RE: Response to Department Comments on 850 Route 28, LLC, T/o Kingston; Ulster County; CM Project 118-207, NYSDOT SEQR 18-175

Creighton Manning Engineering, LLP (CM) has reviewed the comments provided by the Department on June 17, 2019 regarding the proposed 850 Route 28, LLC project in the Town of Kingston. Below is a summary of the comments and our responses, noting that comment #3 did not require a response.

TRAFFIC VOLUMES (240,000 SF)

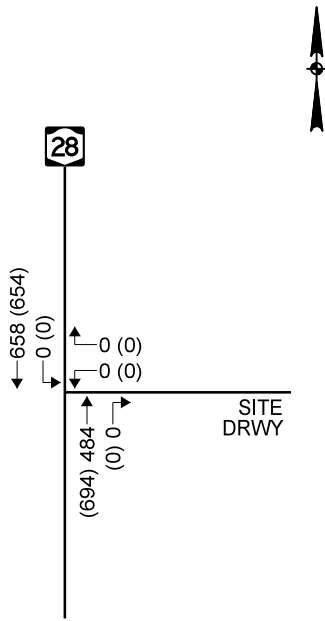
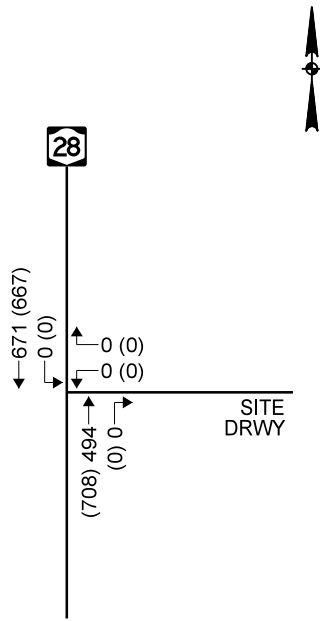
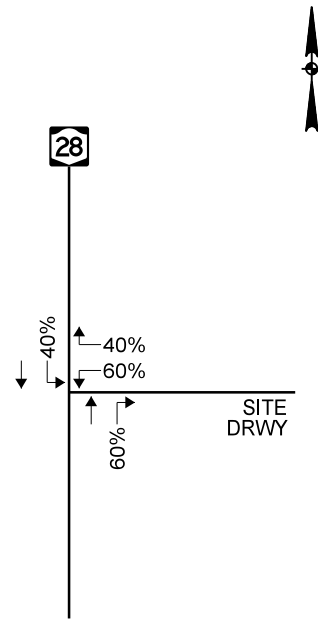
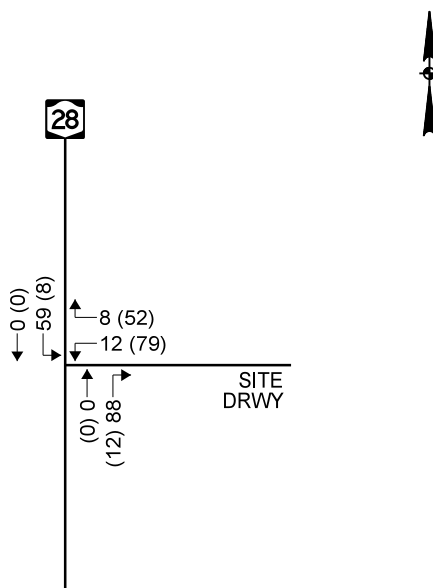
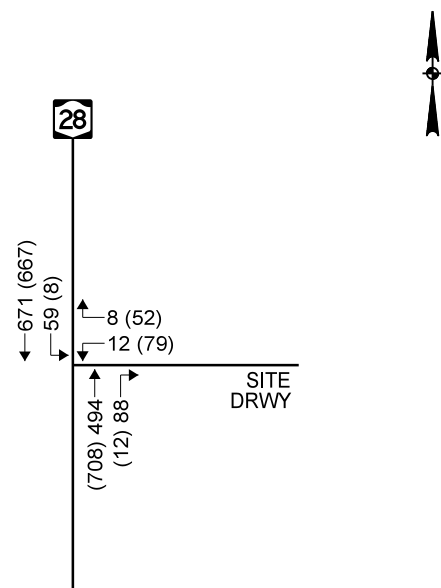
Comment #2: "The Department would like to remind the applicant that if two alternative methods are used to express the trip generation, the Institute of Transportation Engineers recommends using the more conservative approach. The applicant is proposing using values that are significantly below the ITE average for similar facilities. I do not see a justification or more importantly a control that would trigger further Department involvement if the applicant traffic estimation would be exceeded. Any agreement with the current applicant would not survive a sale and the new owner could operate the site to its full ITE traffic generation potential. So the department requests the use of the higher trip generation rates be used on this project."

Response: The tenant specific trip generation is estimated in Table 1, along with the proposed building sizes based on ITE (10th Edition) assuming General Light Industrial. In addition, build out of the site assuming 360,000 SF (hypothetical) of General Light Industrial is also estimated.

Analysis of the proposed operations (240,000 SF – Tenant specific manufacturing) was completed previously (see November 8, 2018 analysis by Creighton Manning). Based on ITE data, the 240,000 SF light industrial use is estimated to generate 168 trips in the AM peak hour and 151 trips in the PM peak hour. These trips have been distributed and assigned to the study area intersection considering comment #4 below and analyzed. Similarly, the 360,000 SF development (hypothetical) was estimated to generate 252 trips in the AM peak hour and 227 trips in the PM peak hour. These trips were distributed, assigned, and analyzed. The summary of each analysis is provided on Figures 2 and 3, and in Table 2.

**HIGHWAY
IMPROVEMENT PLAN
LEFT TURN LANE**
FOR
850 ROUTE 28 LLC
TOWN OF KINGSTON
ULSTER COUNTY NEW YORK

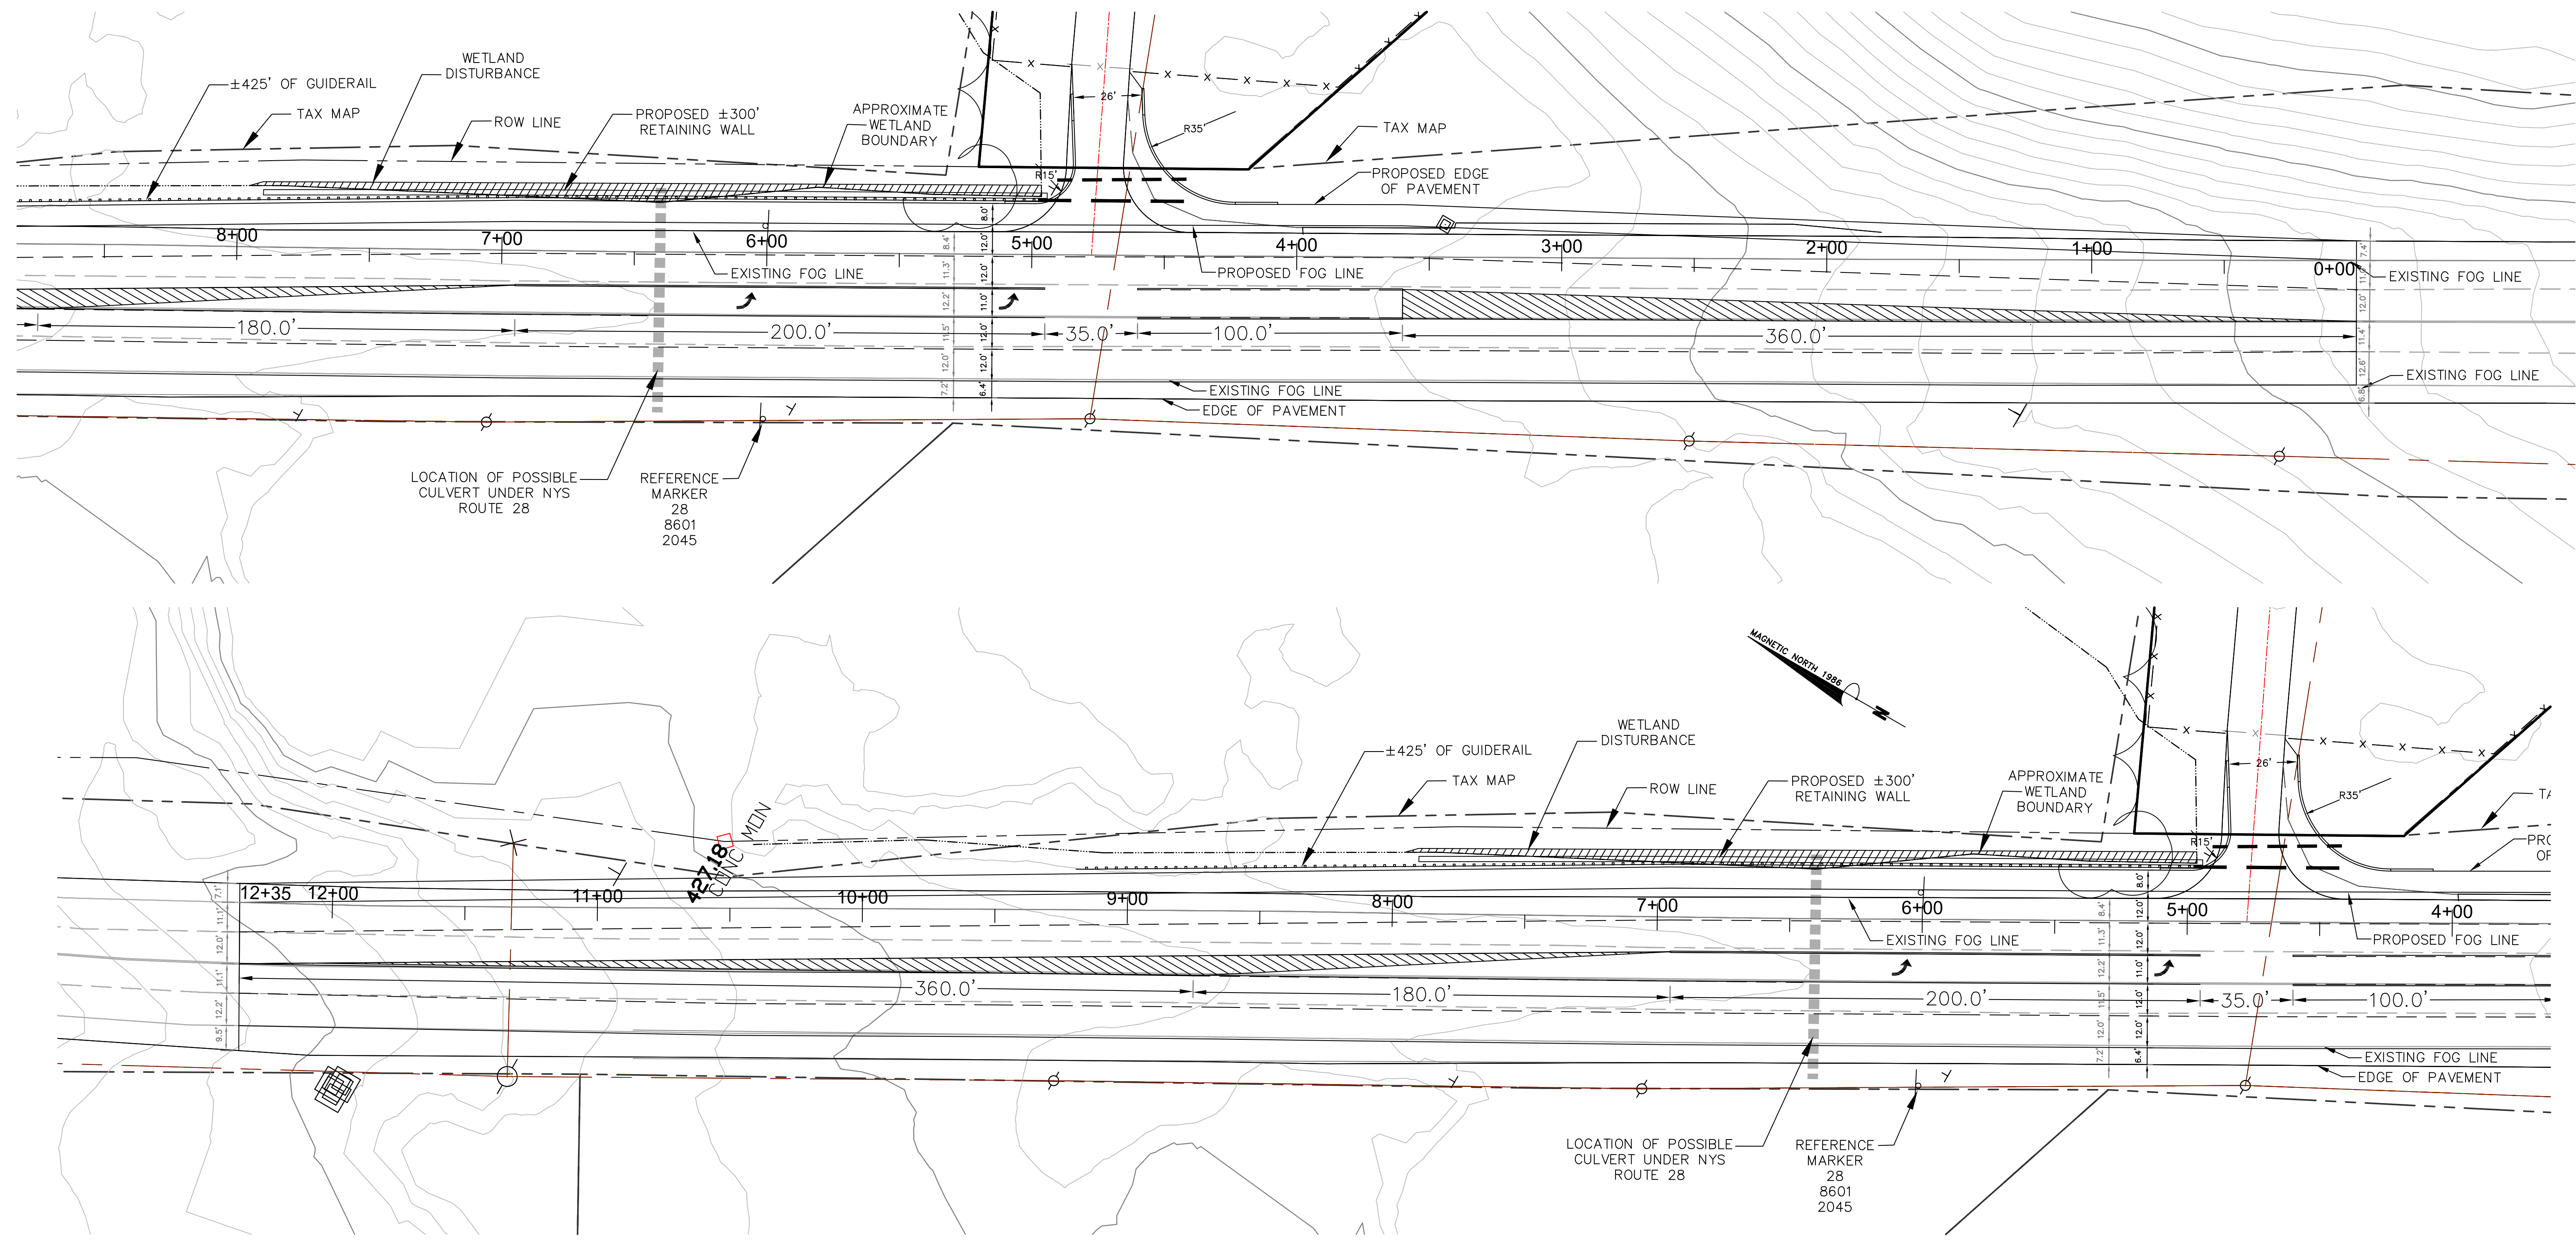
Comment #4: "I agree that as proposed the development would not require a traffic signal at this time. The assertion that the left turn is not required is predicated on the 90 (rights in)/10 (lefts in) split on traffic entering the site (For both AM and PM). There is no justification for this extreme value. Going by the gravity model a 40/60 split (reverse in the PM) is far more reasonable and would meet the requirements for an exclusive left turn lane. 60/40 is much more reasonable assumption based on the tube counts taken from NYS DOT Traffic Data Viewer. Even a 50/50 split would meet the warrants. So the Department will request a

Left turn lane with sufficient storage be provided for this project as part of the highway work permit. Accidents - the Department concurs with the accident study contained in this submission.

Response: Medenbach and Eggers has prepared the attached concept plan for a left turn lane into the site. We note that the widening has been extended downstream to accommodate at two-way left turn lane and allow a two-stage gap acceptance for the left turn egress of the site.
